Model: Cor-C1.5	Date: 02-Dec-16	No.: RD2840013
-----------------	-----------------	----------------

Subject: Firmware Release Note: ProgramInfoService		Prepared by: R. Tsurumi	
From: 1st Tech Service Sect., MFP/Printer Tech Service Dept.			
Classification:	<input type="checkbox"/> Troubleshooting	<input type="checkbox"/> Part information	<input type="checkbox"/> Action required
	<input type="checkbox"/> Mechanical	<input type="checkbox"/> Electrical	<input type="checkbox"/> Service manual revision
	<input type="checkbox"/> Paper path	<input type="checkbox"/> Transmit/receive	<input type="checkbox"/> Retrofit information
	<input type="checkbox"/> Product Safety	<input checked="" type="checkbox"/> Other (Firmware)	<input checked="" type="checkbox"/> Tier 2

Model: Corona-C1.5c		Date: 30-Jan-17	No.: RD284025
Subject: New bottom right cover		Prepared by: Y.Ino	
From: 1st Tech Service Sect., MFP/P Tech Service Dept.			
Classification:	<input checked="" type="checkbox"/> Troubleshooting	<input type="checkbox"/> Part information	<input type="checkbox"/> Action required
	<input type="checkbox"/> Mechanical	<input type="checkbox"/> Electrical	<input type="checkbox"/> Service manual revisio

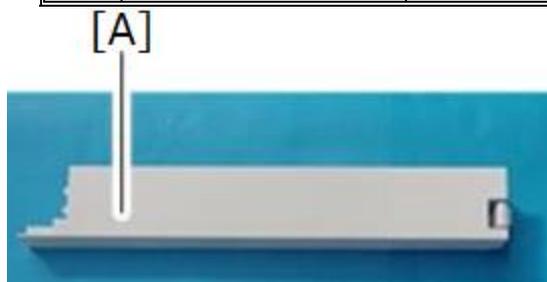
Small insects may get inside the machine from the open space at the bottom right.

Procure and install the cover [A] below.

No	Part Number	Description	Qty
1	D1491268	COVER:RIGHT:LOWER	1

INCORRECT paper transport between FD3000 and SR3210/3220

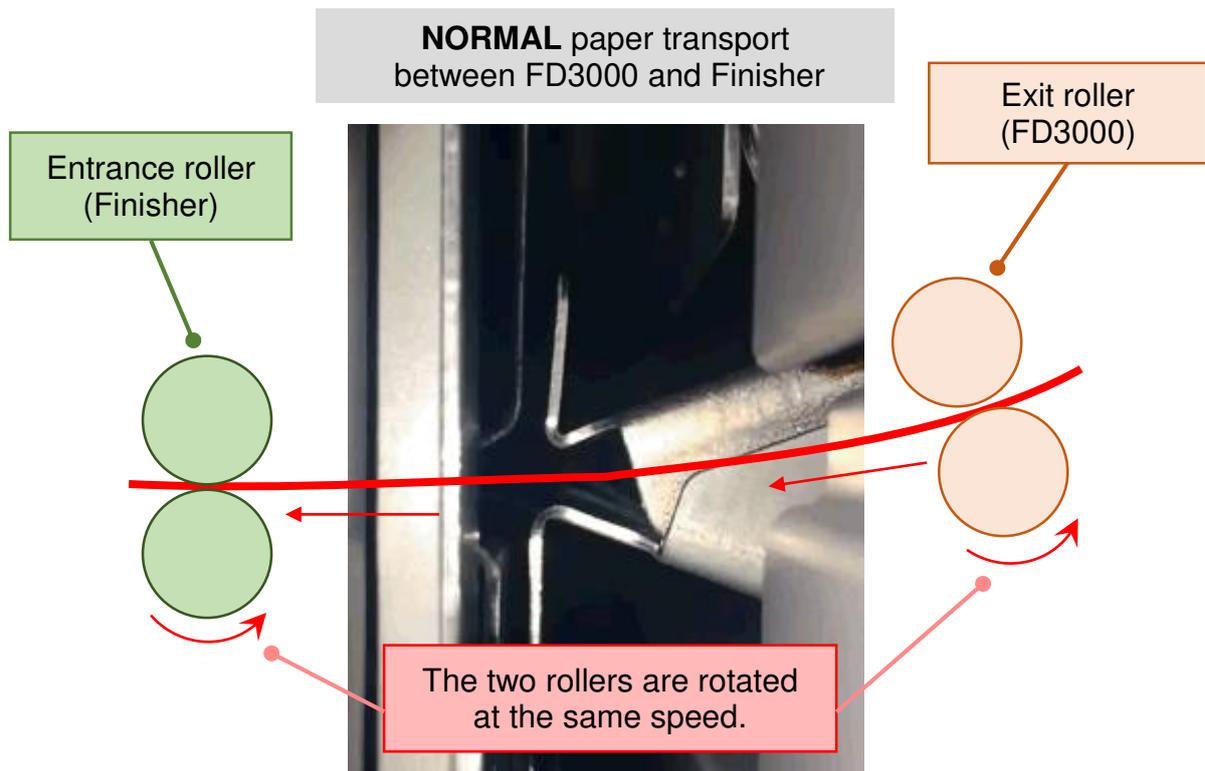
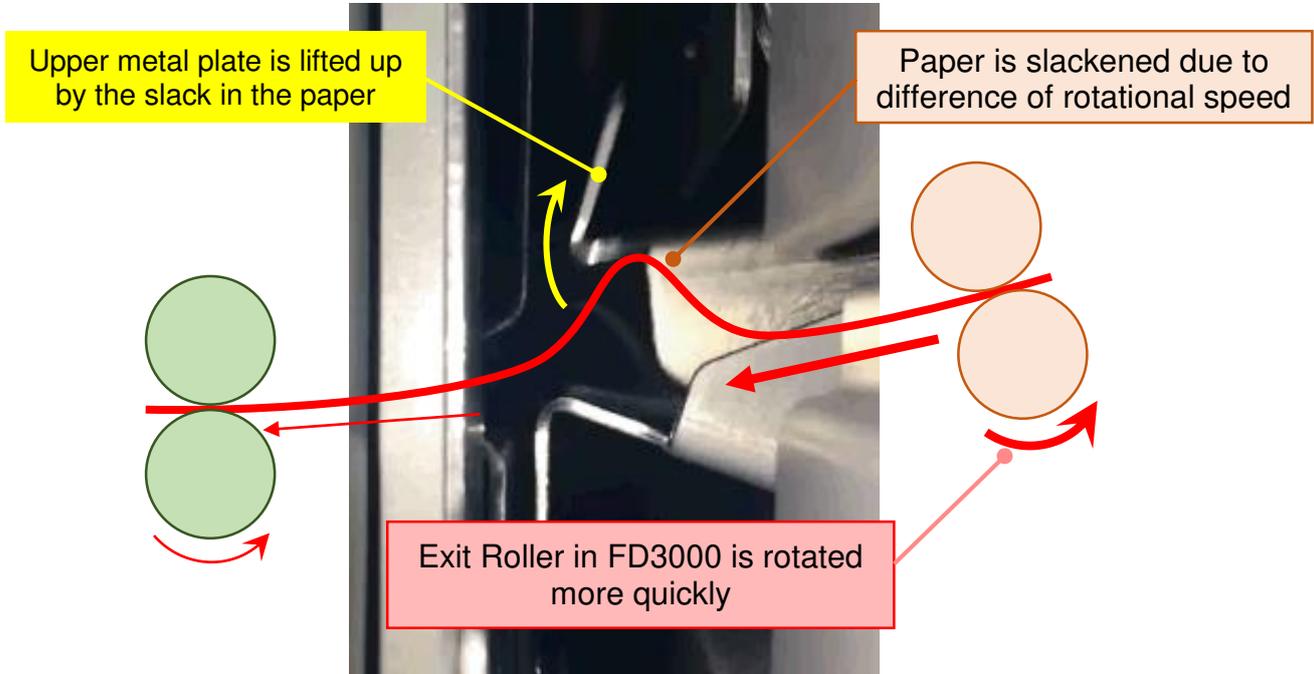
Firmware error (roller rotation speed control)

Due to the above error, the exit roller in the FD3000 is rotated at a higher speed than the entrance roller in the finisher (Normally, these speeds should be the same). This causes slack to develop in the paper, which then lifts up the upper metallic plate. As a result, the upper plate then drops onto the lower plate. Then a metallic “clinking” noise is produced.

The firmware was modified to correct the roller speed control.

Important Notice about IRIPS Font Firmware

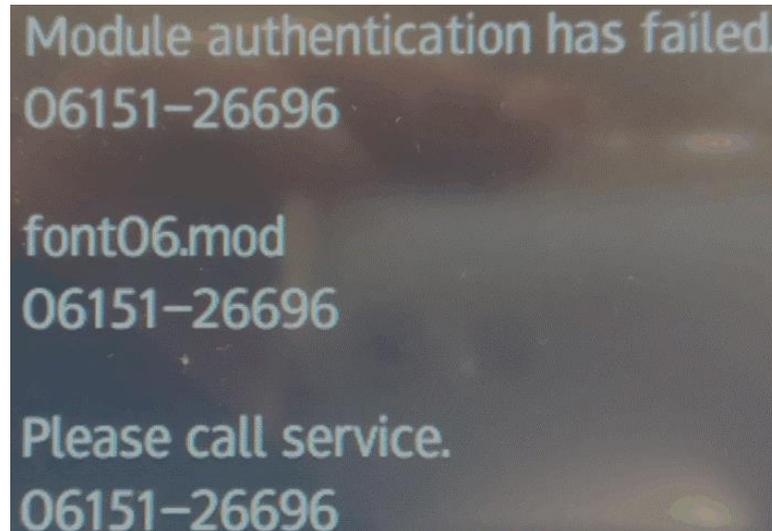
- **DO NOT update** the IRIPS Font firmware with **v1.03** (D2895596) in the field. This is the version that was pre-installed in the initial production lot.
- If you do, the following error message will appear and the main system will freeze. You will then have to replace the controller board.

- If you need to update the IRIPD Font firmware, use the **latest version** (Example: **v1.13**, which has already been released).
- Machines which still have the original v1.03 installed will work normally.

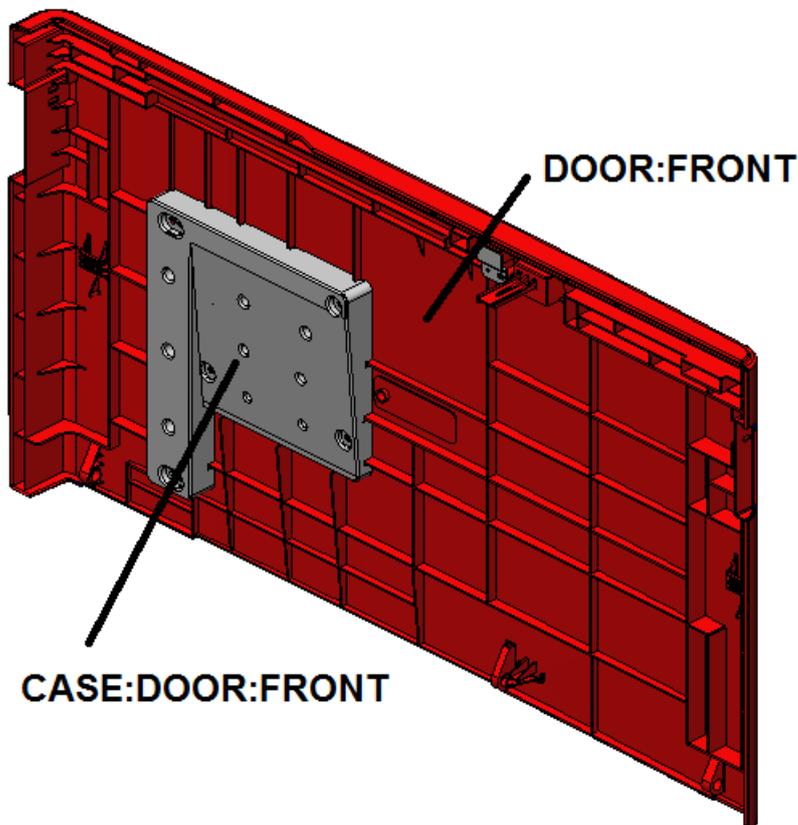
Change: Shape of the front door and front door case.

Reason: To be common with the printer model.

Note: When replacing the front door, replace the front door case also at the same time.

P to P diagram revision

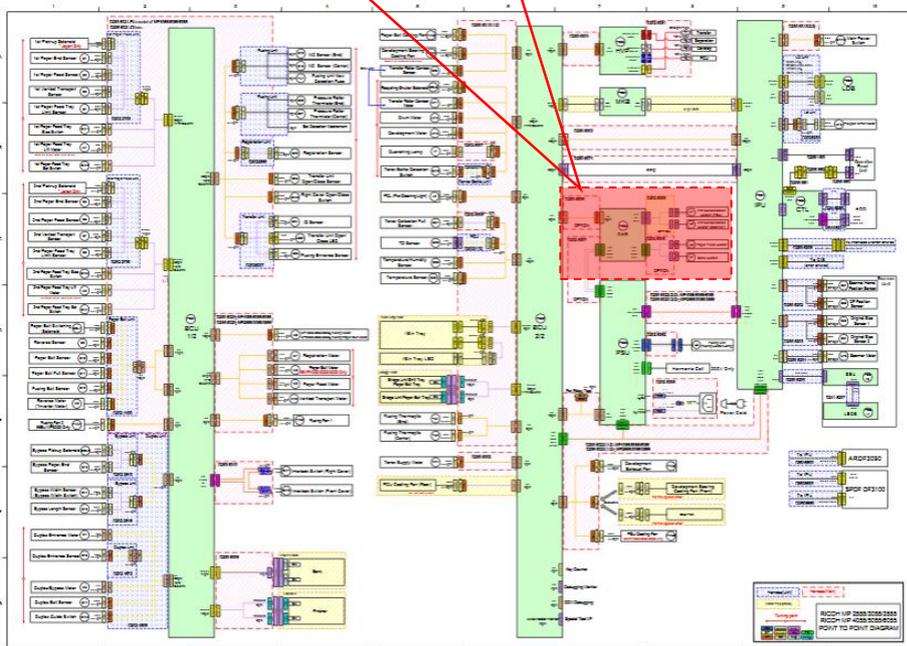
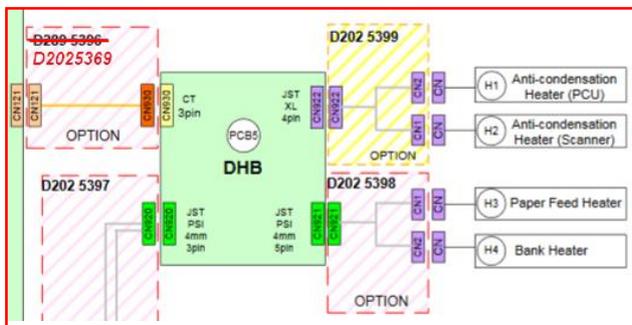
The part number of the harness between DHB and BCU (D2895396) in the P to P diagram is incorrect.

The correct part number is **D2025396**. This is the same as Cor-C1.

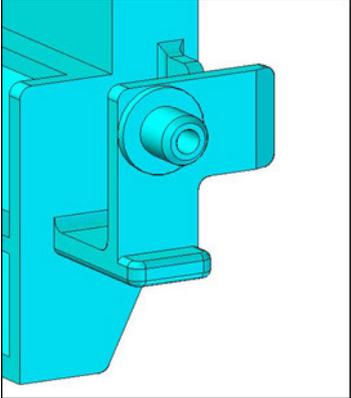
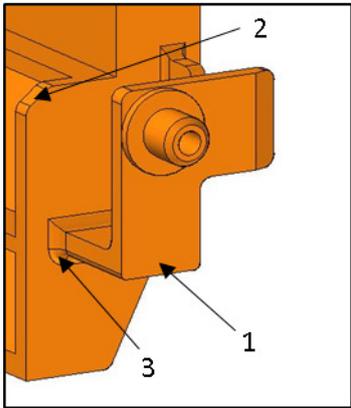
Change: The shape of the guide plate was changed.

Reason: To further strengthen and prevent breaking of the guide plate.

Old D1492721	New D6942721
Shape		 <ol style="list-style-type: none"> 1. Deleted stopper 2. Changed angle regulation 3. Strengthened part

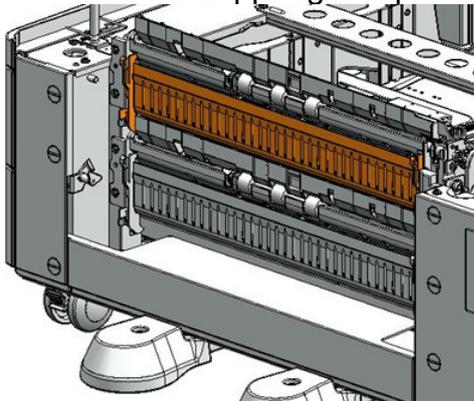
Change: Added cushions and changed the shape of the guide plate.

Reason: To further strengthen and prevent breaking of the guide plate.

Parts catalog correction 3

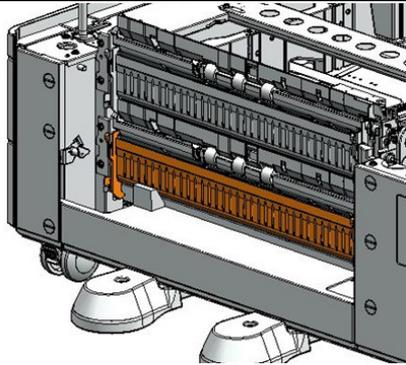
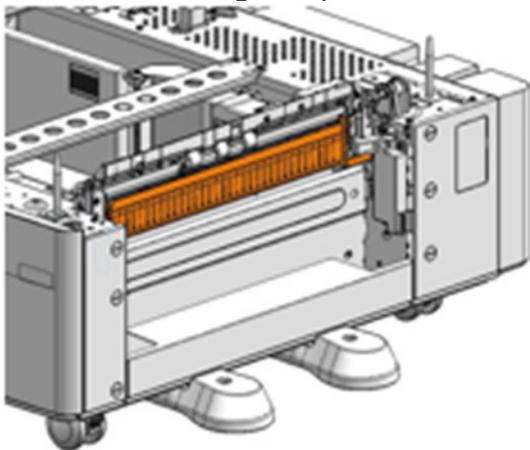
Change: Added cushions and changed the shape of the guide plate.

Reason: To further strengthen and prevent breaking of the guide plate.

Point to Point Revision

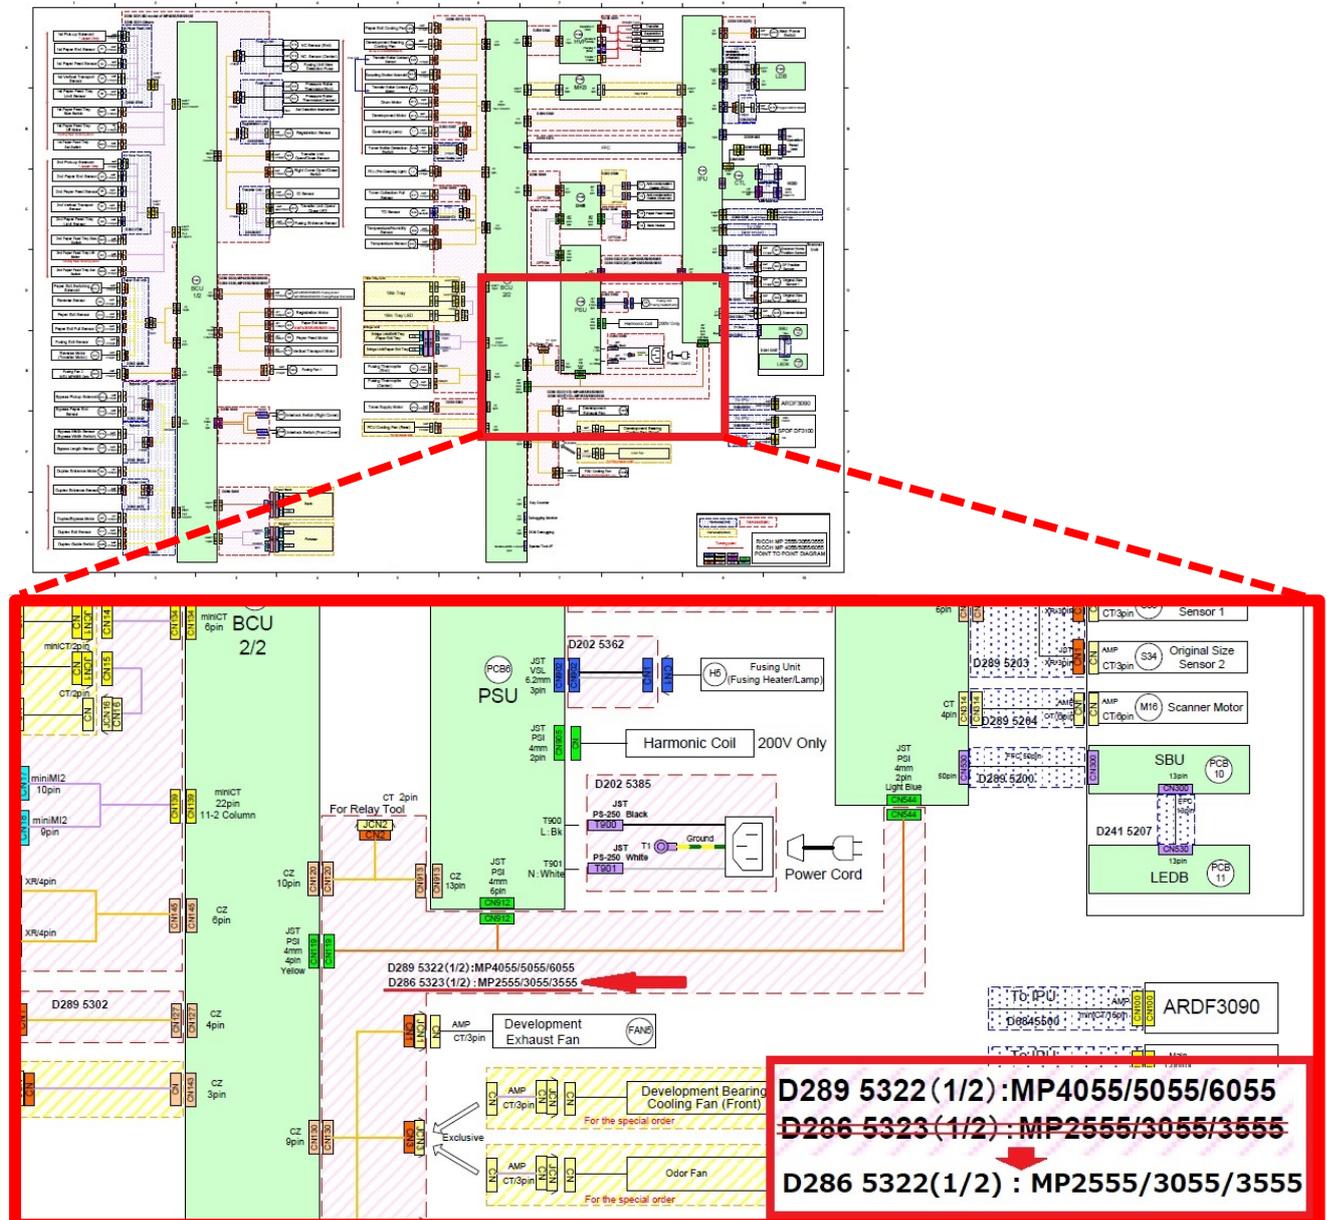
The part number (D2865323) of the harness that runs from the PSU to the IPU and BCU is incorrect. The correct part number is D2865322. The incorrect part number in Point to Point is referred to in the figure below.
